BEAVER VALLEY UNIT 1
TECHNICAL EVALUATION REPORT ON THE
INDIVIDUAL PLANT EXAMINATION
BACK-END SUBMITTAL

Prepared for the U.S. Nuclear Regulatory Commission
Under Contract NRC-05-91-068-32
August 1995

This technical evaluation report (TER) documents the results of the SCIENTECH submittal-only review of the back-end portion of the Beaver Valley Unit 1 (BV1) Individual Plant Examination (IPE) submittal.

Figure 1. Contributors to CDF at BV1 from sequences grouped by initiating events.*

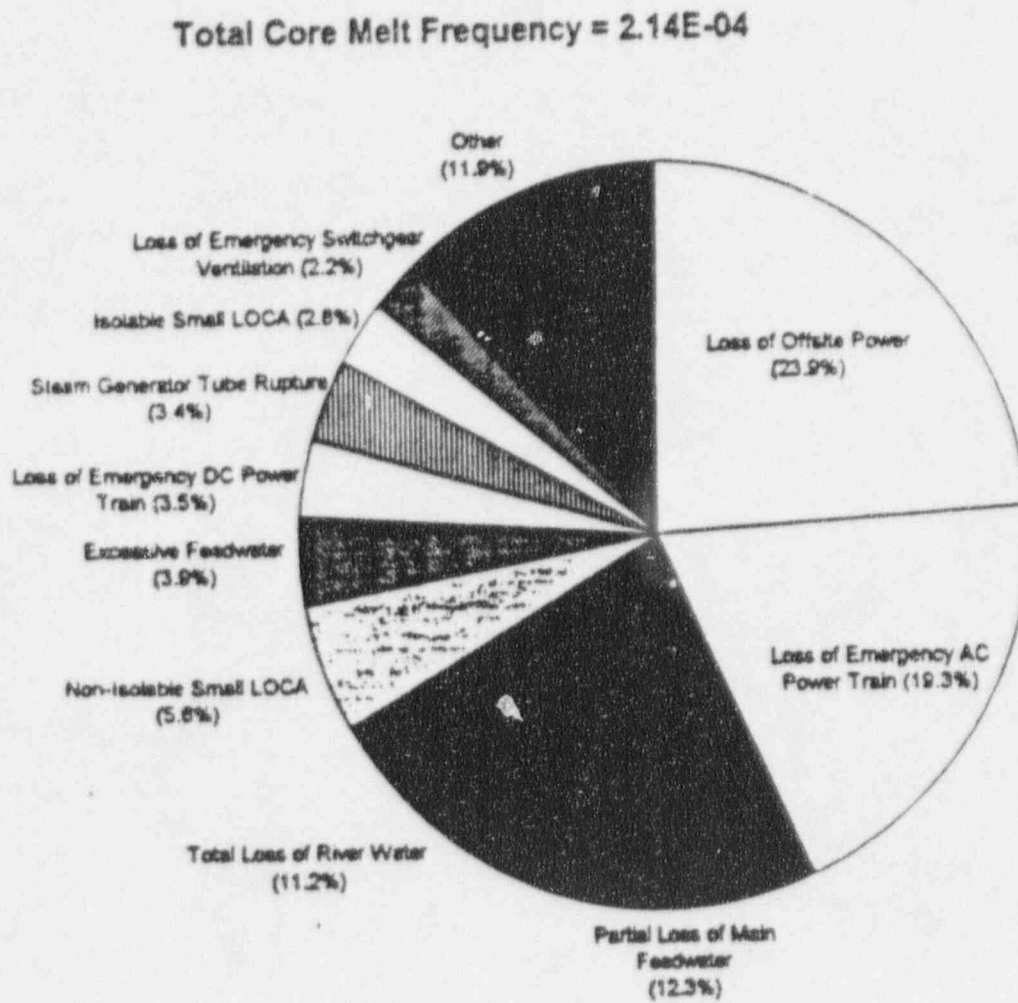
Figure 1, reproduced from the submittal, shows contributors to the BV1 CDF from sequences grouped by initiating event. The total CDF calculated for BV1 from internal initiators was 2.1×10^{-4} per reactor year. One of the important groups of sequences that drove the final results was loss of offsite power (23.9 percent of the total CDF) followed by loss of emergency AC power train (19.3 percent). The next three contributors in descending order of importance were the partial loss of the main feedwater (12.3 percent), total loss of river water (11.2 percent), and non-isolable small LOCA (5.6 percent).
